This is to certify that Northeast Air/Neptune Properties
 has permission to Build a 9576 Storage hanger located at
 AT 1127 Westbrook St 207 B001002

PLANS
AIRPLANE HANGER
 WESTBROOK STREET
 PORTLAND, MAINE

City of Portland, Maine - Building or Use Permit Application

City of Portland, Maine - Building or Use Permit

1 1st FLOOR PLAN
 SCALE: 1/8" = 1'-0"

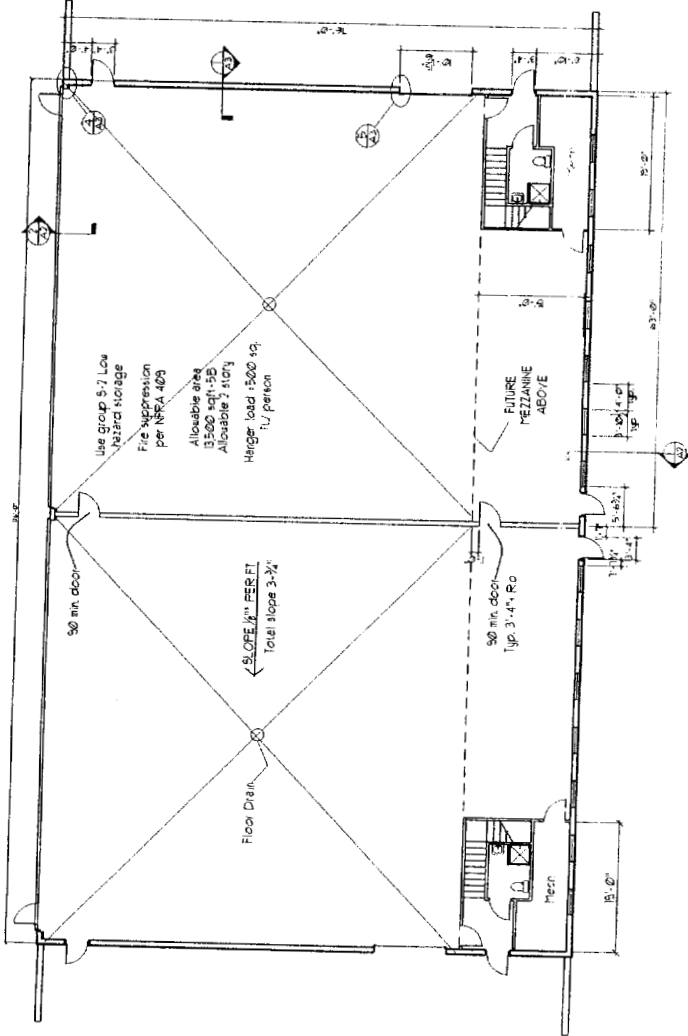
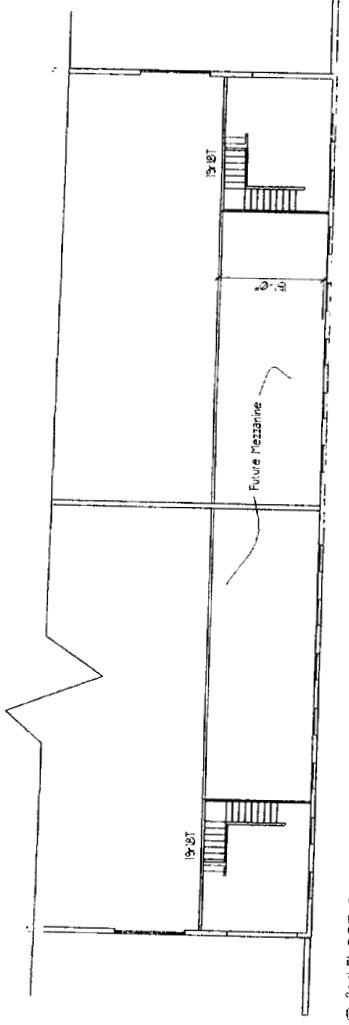
1/30/06 Bill N. brought down a stamped site plan but is still waiting for performance guarante etc. There is a difference in building size - the site plan shows 70' x 126' & the building plans show 76' x 126' - Mike Scarks says the final site plan will show 76' x 126' and will meet the 20' minimum front setback

5 DETAIL OVERHEAD DOOR JAMB
SCALE 1" = 1'-0"

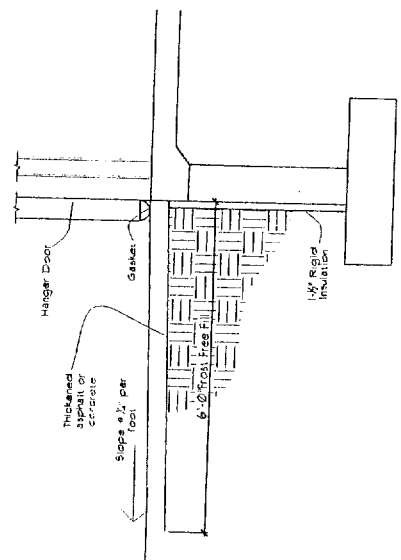
- 1) The following items must be submitted and approved prior to commencement of those activities;
 - 1) Shop drawings for the overhead door installation.
 - 2) Electrical and Fire alarm system designs demonstrating code compliance.
 - 3) HVAC equipment info demonstrating Code Compliance with Section 412.2.4 exception 2
 - 4) Roofing materials must be approved.
- 2) Because the Design Professional has designated this building an S2 structure, aircraft storage ONLY is allowed , no repair work is allowed.
- 3) The request to waive the 2 hr. Rating of the first 28 feet of the right front wall, that is less than 30 feet from the R.O.W. Is granted as the actual fire separation distance as defined in shapter 7 exceeds 55 feet.
- 4) Flor Drains must be protected in accordance with Section 412.2.3. Of the 2003 IBC
